Discretionary Review Hearing
Case Number 2019-002243DRP
439 Hill Street

RESPONSE TO DISCRETIONARY REVIEW (DRP)

Re: Project at 439 Hill St

Figure 1: Panoramic view of windows in East façade light well (facing 439 Hill Street) in 451 Hill Street

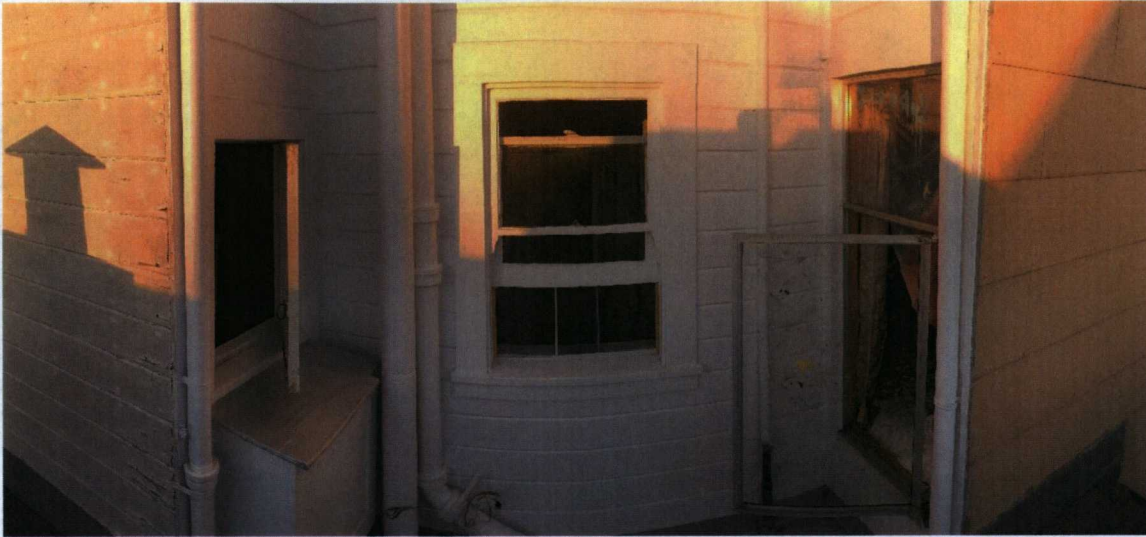
Not shown in the permit submittal information, there are actually three windows in my lightwell that faces the subject project (see the photographs in Figures 1 through 4 at the end of this letter). Due to the extended height of the proposed 439 Hill Street building modification, both lighting and ventilation through those windows will be severely impacted. In fact, at the request of Carolyn Kenady, of the Dolores Heights Improvement Club, given at the time of the Pre-Application Meeting for the project on 9 January 2019, the Architect Alex Terry later produced a computer-based Light and Shadow Model, which demonstrated the significant impact the project would have on my residence. These windows serve, from right to left in the photo:

A3.4

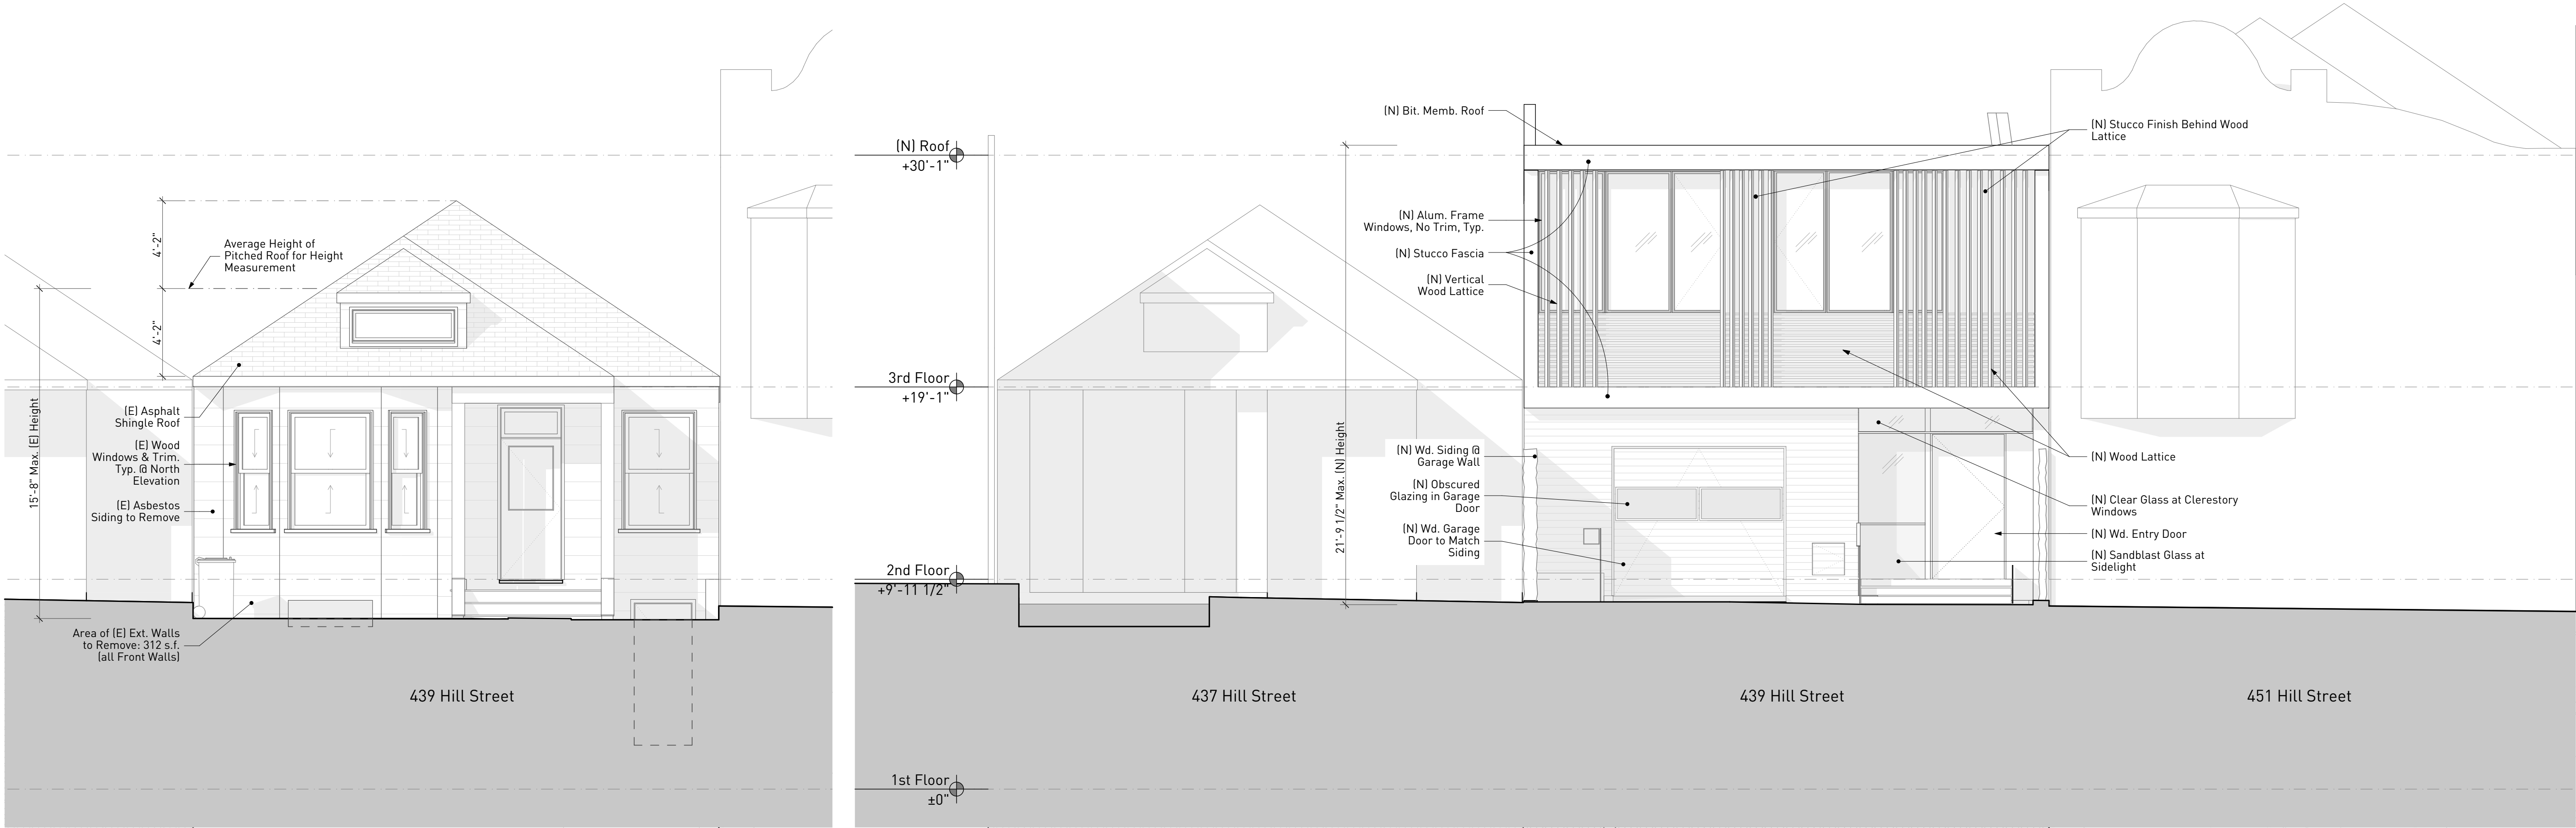
² Note that the depth of the lightwell in 451 Hill Street is incorrectly given as 2'-11" on drawing A3.4. It is actually 3'-4.5" in depth, which should be noted if an actual "mirror" condition (per the Scope of Work on Page A1.1) is to be achieved.

Extensions above Roofline. There are extensions above the roofline shown on Drawing A3.4 and A4.1 near the skylights. The height of these extensions is not given. (It is also not known whether this was included in the Architects Light and Shadow model, but it certainly could further affect lighting.)
